**UNITED STATES
NUCLEAR REGULATORY COMMISSION
REGION IV
611 RYAN PLAZA DRIVE, SUITE 400
ARLINGTON, TEXAS 76011-4005**

**SUBJECT: DIABLO CANYON POWER PLANT - NRC SPECIAL INSPECTION TEAM
REPORT 05000275/2003010 AND 05000323/2003010**

Diablo Canyon Nuclear Power Plant, Units 1 and 2
NRC Special Inspection Report 50-275/2003-010; 50-323/2003-010

Gate Filter Module

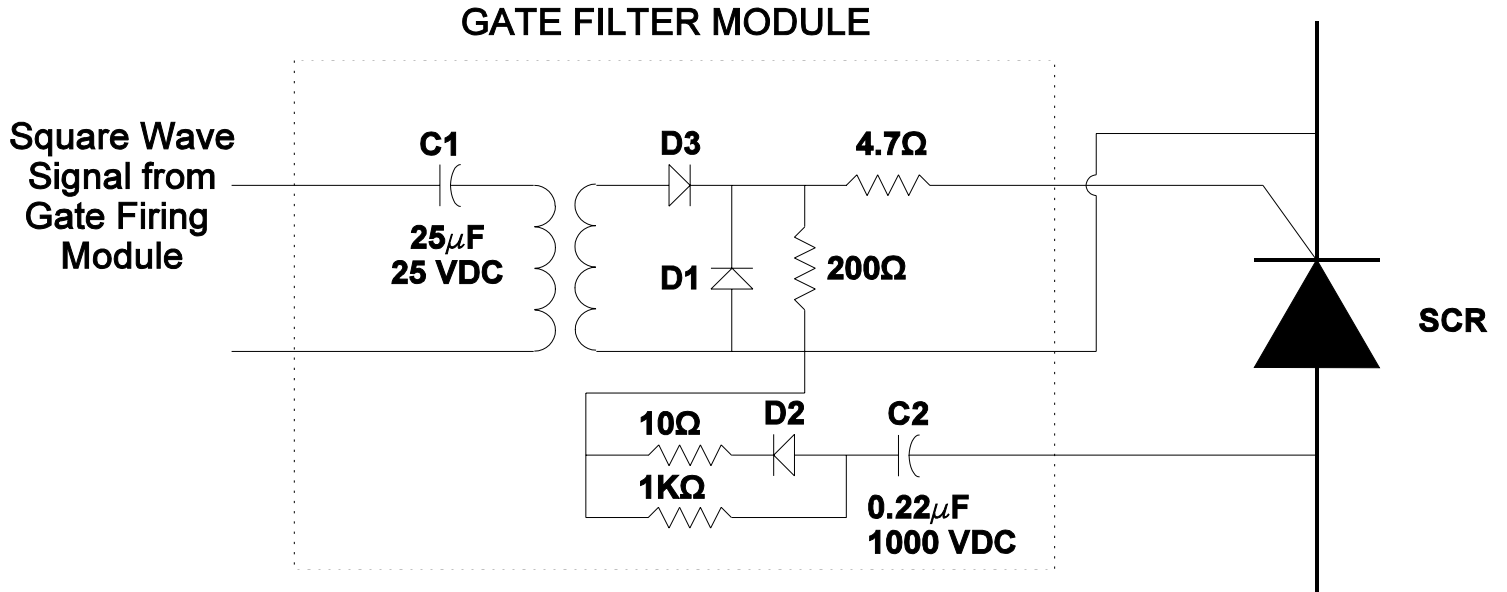
sequentially. As shown in Attachment 3, the gate filter module contains an electrolytic capacitor denoted as "C1." The purpose of the capacitor is to filter out noise and allow the high frequency pulse signals to pass.

The C1 capacitor is a polarized electrolytic capacitor. As such, it is designed for only positive voltages from the gate firing module. If negative voltages are experienced on a continual basis, the service life of the electrolytic capacitor is sharply reduced. If the C1 capacitor fails, the respective gate filter module will not send a turn-on signal to its respective SCR. If the capacitor loses capacitance, the gate filter module will send a degraded pulse and the SCR may or may not turn on. Such a failure would leave five SCRs functioning, which would be sufficient to maintain output voltage and current under normal plant loads. However, under full load, the demand would increase the load experienced by the remaining SCRs to the point where protective fuses would be challenged. The battery chargers experienced full load conditions only a limited number of times during the previous operating cycles. These occurred during battery charger or battery surveillance testing. The team noted that normal equipment monitoring would not likely detect the condition, such that a battery charger could operate with a failed SCR for an extended period of time.
